NOVI SENIOR COMMUNITY PROJECT JSP17-66

PLANNING REVIEW

Review Date: January 26, 2018
Review Type: Revised Preliminary Site Plan
Project Name: JSP17-66 Novi Senior Community
Plan Date: January 14, 2018
Prepared by: Sri Ravali Komaragiri, Planner
E-mail: skomaragiri@cityofnovi.org; **Phone:** 248.735.5607

PROJECT NO: 16874, SHEET NO: C-5, DATE: 05/16/17, SCALE: 1" = 40'

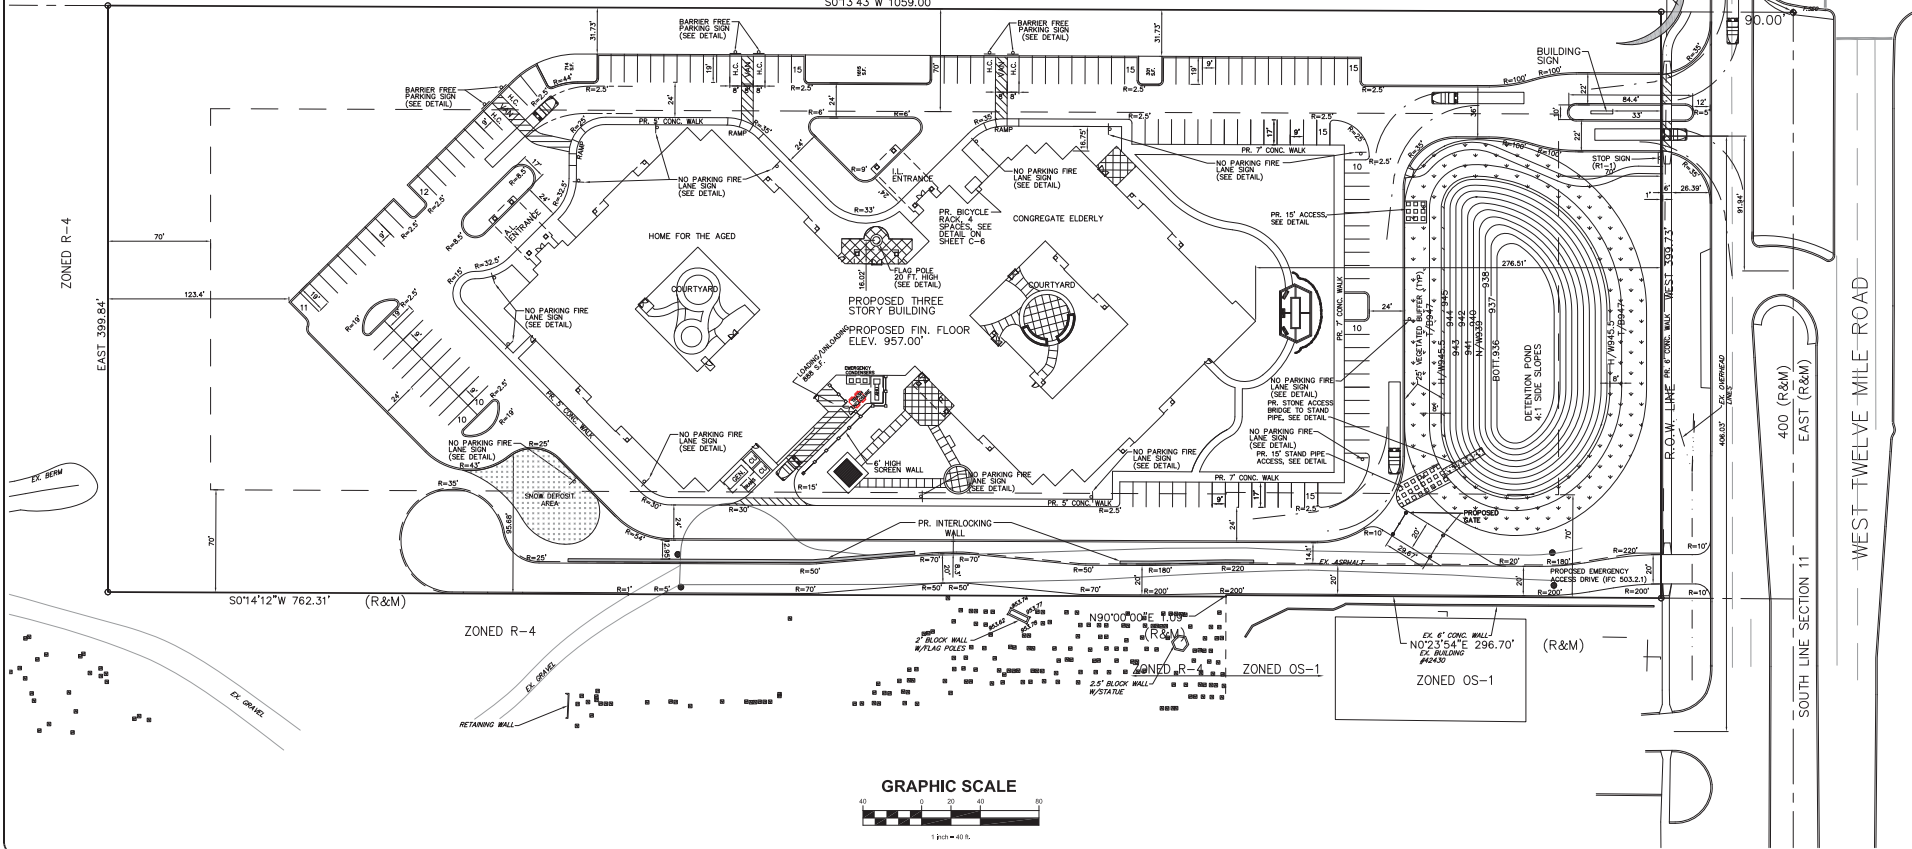
4. Cemetery access road: The current plan is proposing the cemetery access with a width of 18 feet. The applicant has agreed to revise the width to 20 feet based on discussions with the City staff. Please provide a revised site plan in PDF format prior to Planning Commission meeting.

9. Photometric Plan: A photometric plan is required prior to Planning Commission's approval of Preliminary site plan, if the subject property abuts residential district. **A plan was provided with pre-application review, but not currently. All comments for photometric plan in the Plan review chart refer to the plan provided at the time of Pre-application meeting. Please include sheet PM-1 along with other information requested.**

- c. The applicant shall increase the width of the cemetery access drive to 20 feet at the time of Final Site plan submittal;
- d. City Council variance from Sec. 11-216 (c) (8) of Novi City Code for absence of a right turn taper lane along Twelve Mile Road;
